**APPLICATION FOR PERMISSION
UNDER SECTION 16 OF
THE TOWN PLANNING ORDINANCE
(CAP.131)**

Proposed Temporary Public Vehicle Park for Private Car for a Period of 3 Years
at
Lot 733 S.D ss.11 (Part) in D.D. 99, Yan Shau Wai, San Tin, Yuen Long, N.T.

Annex 1 Drainage Assessment

Our response to the comments of CE/MN, DSD is as follow:

Figure 5

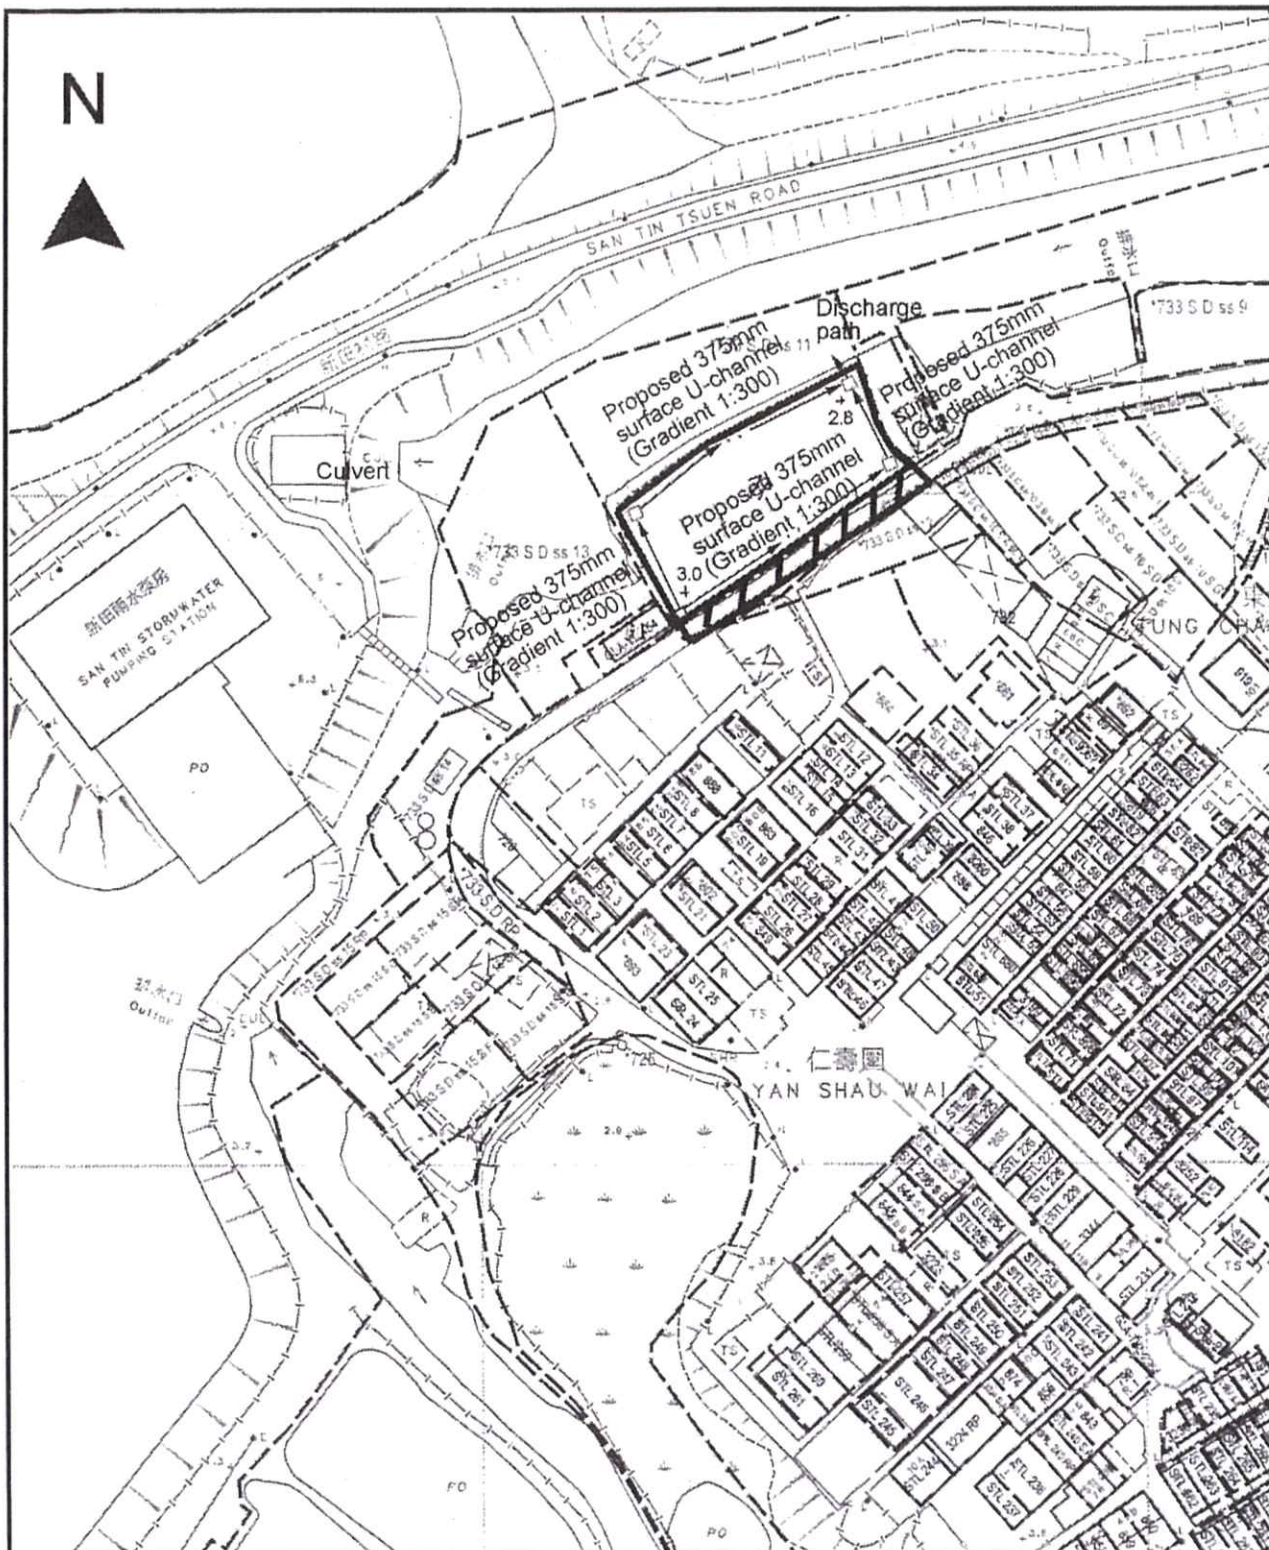
(3) The drainage proposal submitted by the applicant is unacceptable from drainage operation and maintenance point of view. The applicant is requested to duly address comments, as detailed in Appendix IV, and resubmit the proposal to DSD for consideration.

Figure 1

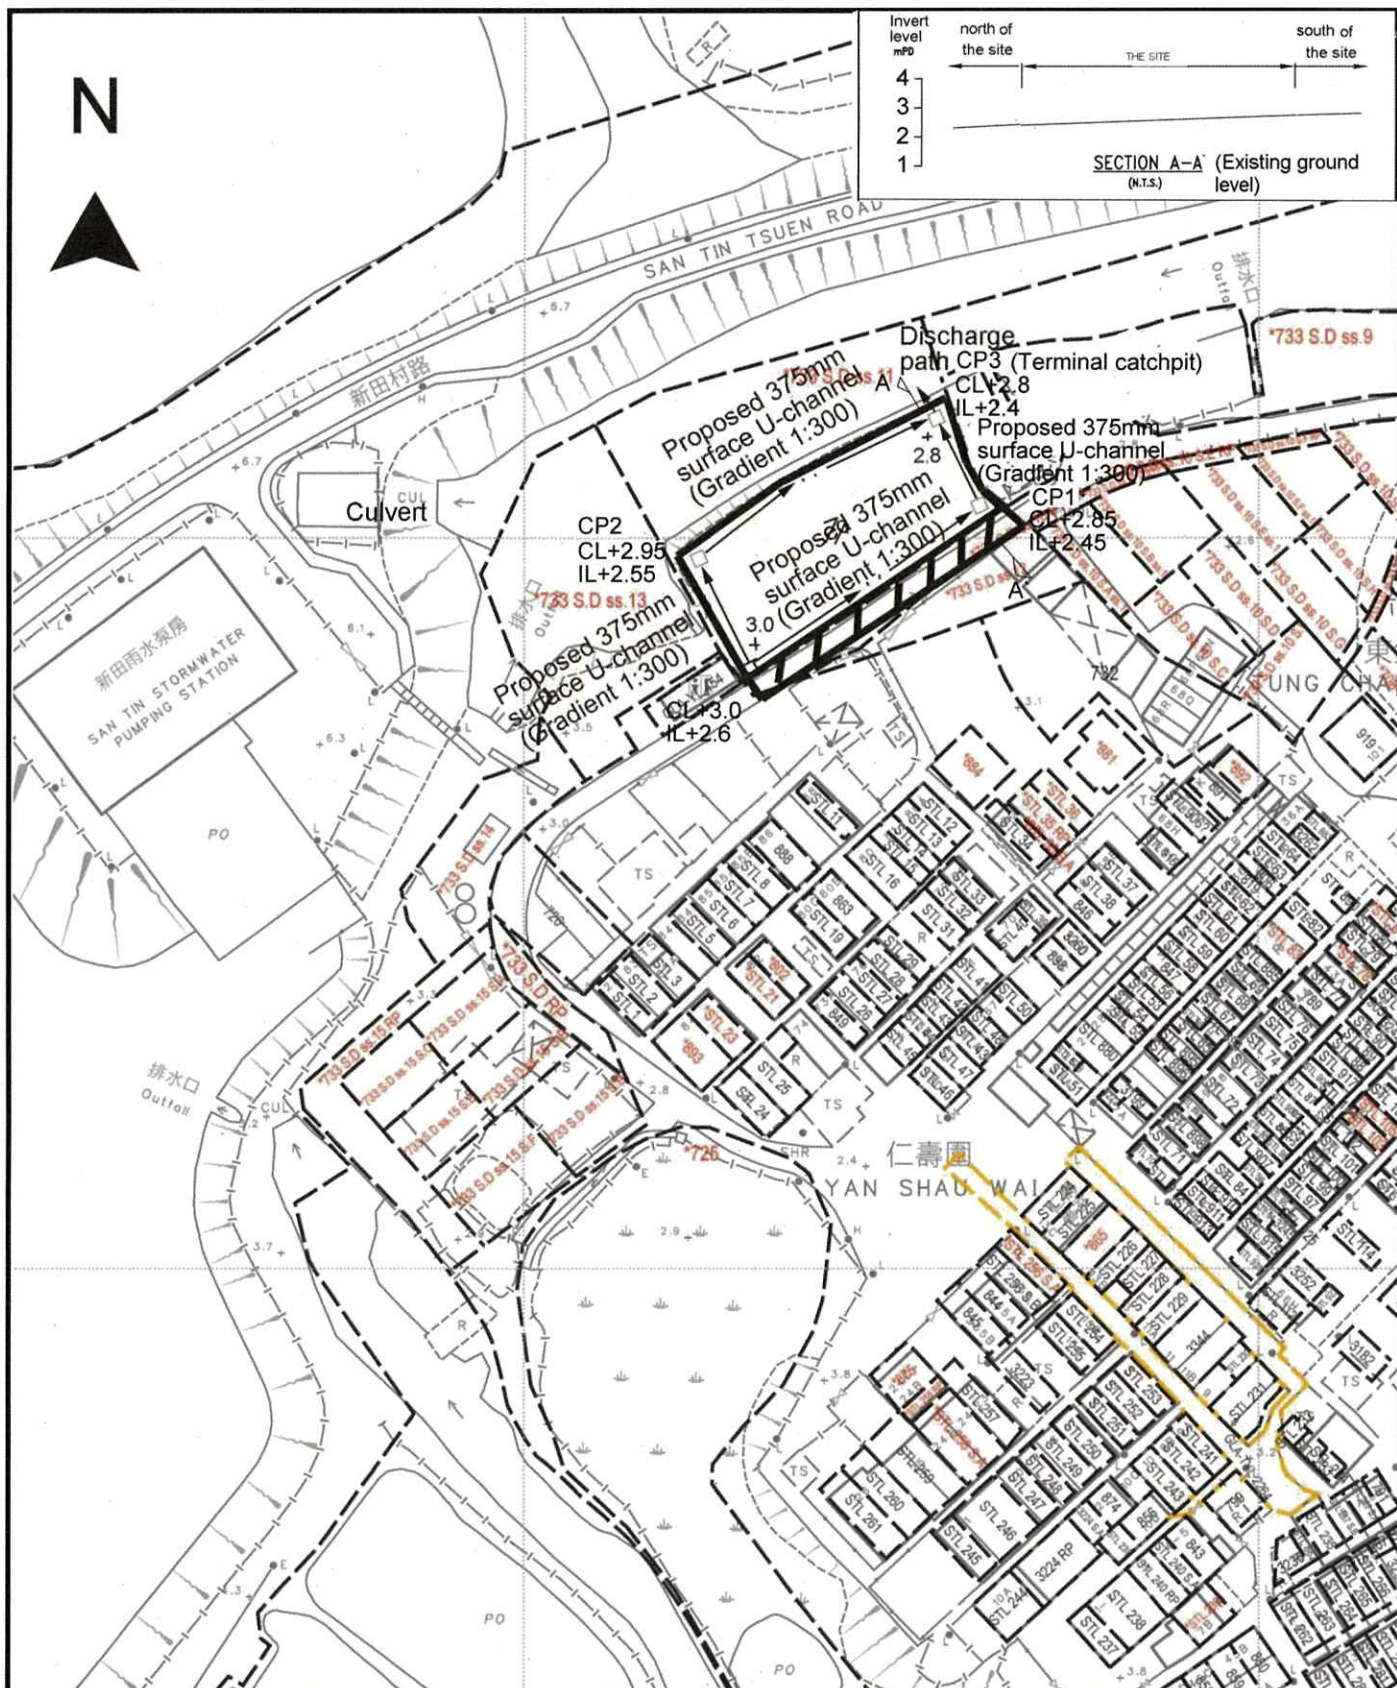
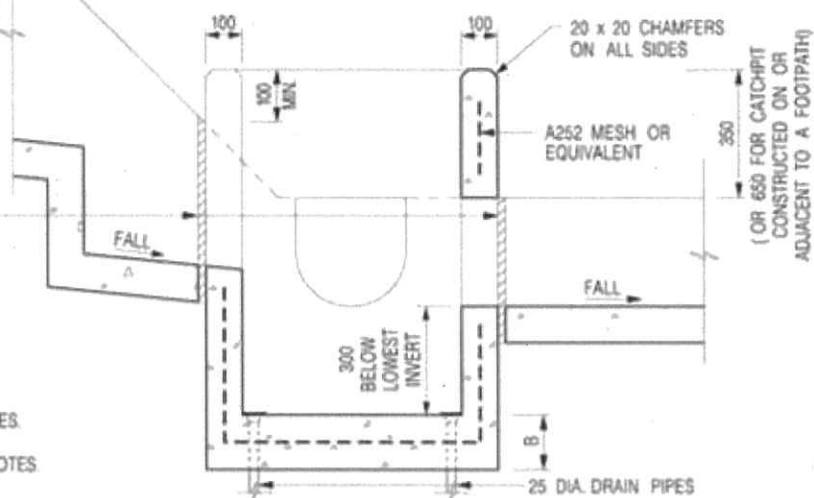
- a) The drainage plan submitted is too small, unclear and without the required detailed information as mentioned in (i) above. Please revise accordingly.

- b) All manholes should be numbered and marked with invert levels to demonstrate that there is no backflow effect.
- c) The last manhole should be specified on plan. Details of the manhole with sump pit should be provided.

CE/MN, DSD's comment	Response
a) The drainage plan submitted is too small, unclear and without the required detailed information as mentioned in (i) above. Please revise accordingly.	Noted. Please see updated Figure 1.

b) All manholes should be numbered and marked with invert levels to demonstrate that there is no backflow effect.	Noted. Please see updated Figure 1.
c) The last manhole should be specified on plan. Details of the manhole with sump pit should be provided.	Noted. The last catchpit will be provided with sump pit. The details is shown in Figure 6.

Cross sectional plan showing details of the discharge point with invert level

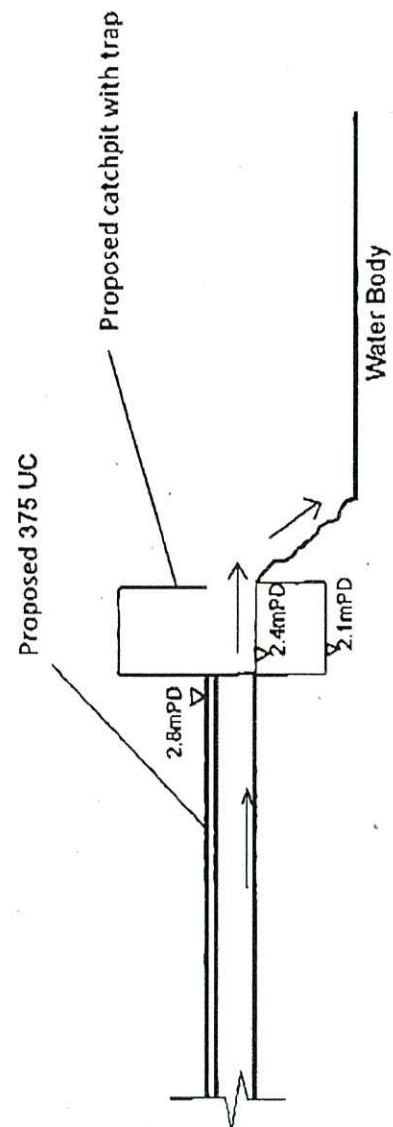
- d) For the proposed discharge point & flow path; please provide:
 - i) Please provide a cross sectional plan showing details of the discharge point with invert level. Please verify that there will not be any backflow effect with the use of invert levels.

The cross sectional plan showing details of the discharge point with invert level is shown in the attachment. There will not be any backflow effect with the use of invert levels.
